Revised and Resubmitted
LAKE COUNTY ENGINEER'S OFFICE
Date: 5-1-96
JULI ANN, E.S., M.E., P.E.
Professional Engineer
by: David B. Jones

REV. PER LAKE COUNTY HEALTH DEPT.
4. SLOPED CURTAIN DRAIN
LAKE INC. APRIL 28/1996

SITE PLAN for
SIGNATURE HOMES, Inc.

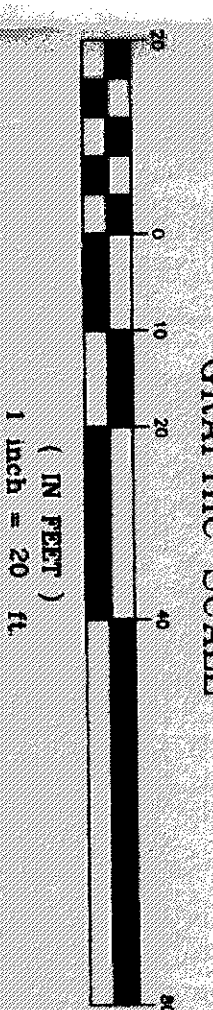
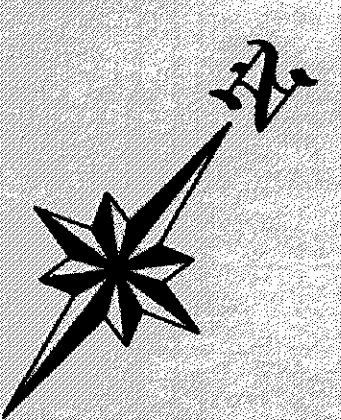
ZONING PERMIT B5516-8451
ISSUED 4/28/96
SUBJECT TO APPROVAL BY:
Lake County Sanitary Eng. ☐
Lake County Eng. Dept. ☒
Lake County Planning Comm. ☐
Lake County Bldg. Dept. ☐

A yard drain must be installed before a septic permit will be issued.

Curtain Drain

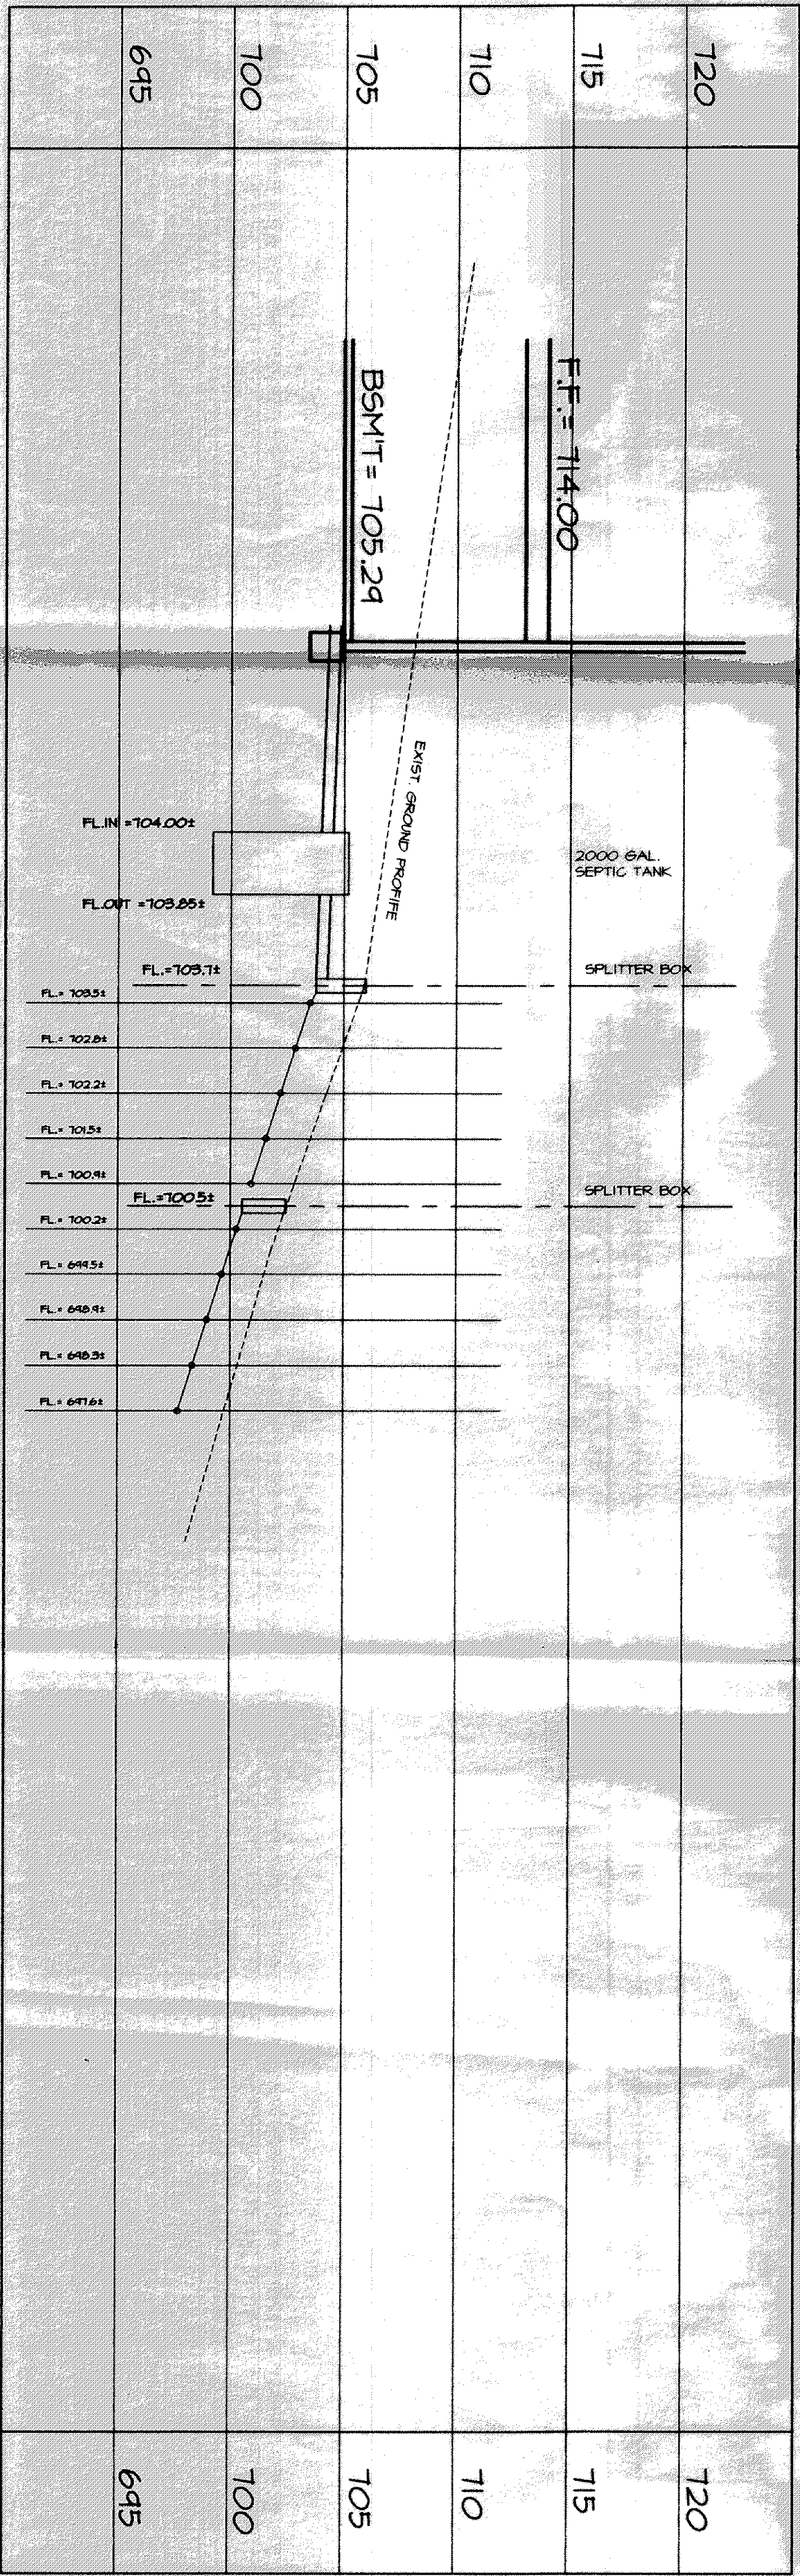
- Minimum width of trench for curtain drain to be 12 inches
- Minimum slope of curtain drain will be 6 inches in 10' foot
- The curtain drain will have an inspection port at the collection point of all four sides
- The outlet of the curtain drain will be protected from the entrance of small animals
- This design is for fields with a maximum width of 36 feet including curtain drains. When width exceeds 36 feet, differential between trenches will be increased to 2.5 feet
